## CPS 9182/1 – Responses to Public Submissions from the Revised Proposal’s Re-advertising in December 2022

On 8 December 2022, CPS 9182/1 was re-advertised on the department’s website with a 7 calendar day submission period, inviting public comment on the revised application of 3.16 hectares, due to a revision to the proposed trail alignment to divert the trail around an area of granite. Sixteen submissions were received within the specified timeframe. The 16 submissions received during the re-advertisement of CPS 9182/1 raised similar matters to the nine submissions received during the initial 21 calendar day submission period on 24 April 2021 and a response to these matters is available at <https://ftp.dwer.wa.gov.au/permit/9182/>.

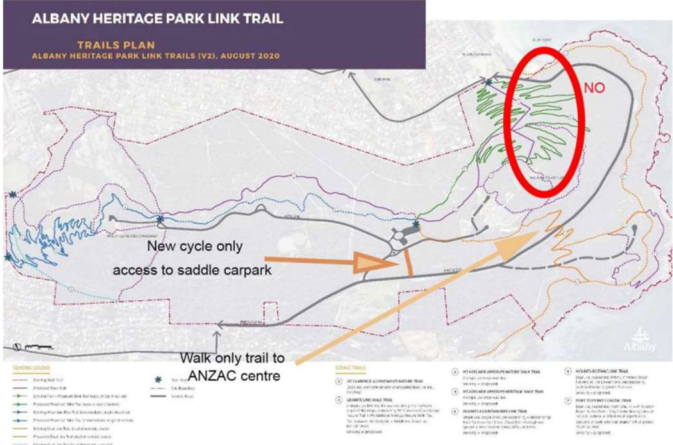
Item	Submission	City of Albany Response	City of Albany comment
1	Submission 4 raises concern that the proposed trail alignment between Marine Drive and trails north of Forts Road will result in extensive clearing within intact and undisturbed native vegetation on Mount Clarence and Mount Adelaide (see Figure 1 below). The submission proposes two alternatives to clearing in this area that would provide access for cyclists between Marine Drive and the top of Mount Adelaide.	No modification or action required	The alignment of these trails has been informed by considerable environmental assessment, avoiding potential habitat areas for significant flora and providing buffers from potential nesting / roosting sites of significant fauna. The trails project is to provide a well-balanced, site responsive trail network system, linking major destinations, neighbourhoods and activity nodes. These mountain bike trails are aimed at beginners and are designed to be family-friendly. Forcing users to use public roads in lieu of a properly designed trail would be a major safety issue, as well as reducing the amenity of the trail network. The proposal relating to cycle and dual-use trails has already been pared back to a minimum, and these two trails (ascending and descending) are necessary to achieve the key purpose of safely linking the Mounts to the tourism precinct of Middleton Beach.
